# Access Compliance Report

## Public Rights-of-Way

Intersection ID: 49314	Main Street: WESLEY_ALAN_LN	Cross Street: ROCKLAND_DR	Location: SE
ADA ID: 9CAAF7C8D50E	Ramp Type: PerpDiag	Initial Pass/Fail: Fail	Overall Compliance: No
Severity Score: 33.75			
Codes/Mitigation Info/Possible Solution		Field Measurements/Component Compliance

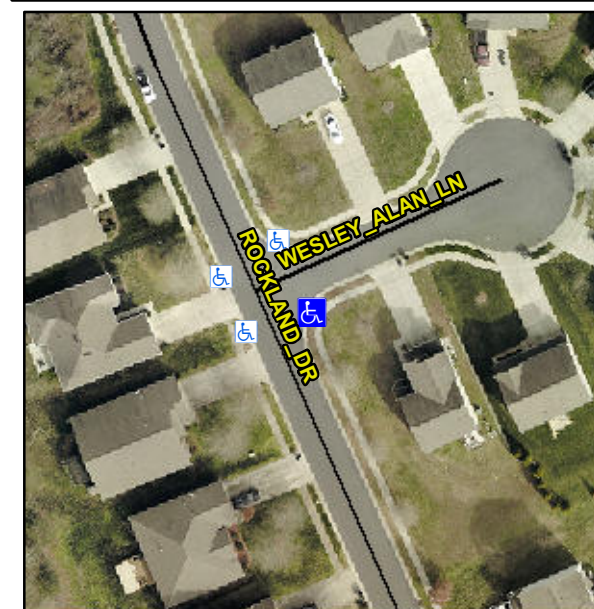
**Not Found, R304.5.1, R304.5.3**

Compliance	Description	Data	Compliance	Description	Data
N/A	Ramp Length (in)	47.0	Yes	Ramp Slope (%)	6.1
No	Ramp Width (in)	47.0	No	Ramp XSlope (%)	11.5
N/A	Flare Type LT	N/A	N/A	Flare Type RT	N/A
N/A	Flare Slope LT (%)	N/A	N/A	Flare Slope RT (%)	N/A
N/A	Flare Traversable LT?	N/A	N/A	Flare Traversable RT?	N/A
N/A	Landing Length (in)	N/A	N/A	DWS Provided?	N/A
N/A	Landing Width (in)	N/A	N/A	DWS Contrast?	N/A
N/A	Landing Slope (%)	N/A	N/A	DWS Length (in)	N/A
N/A	Landing X Slope (%)	N/A	N/A	DWS Full Width?	N/A
N/A	Landing Curb? (Y/N)	N/A	N/A	DWS Offset (in)	N/A
N/A	Shared Landing?	N/A			
N/A	Gutter Ponding?	N/A	N/A	Gutter Slope (%)	N/A
N/A	Gutter Lip Ht (in)	N/A	N/A	Gutter X Slope (%)	N/A
N/A	Painted X Walk1?	No	N/A	Painted X Walk2?	No
	X Walk 1 Direction	To N		X Walk 2 Direction	To W
N/A	X Walk 1 Width (in)	N/A	N/A	X Walk 2 Width (in)	N/A
	X Walk 1 Slope (%)	4.3		X Walk 2 Slope (%)	6.4
	X Walk 1 X Slope (%)	6.1		X Walk 2 X Slope (%)	6.7

**Remove & Replace Curb Ramp With Two New Directional Ramps or Equivalent.**
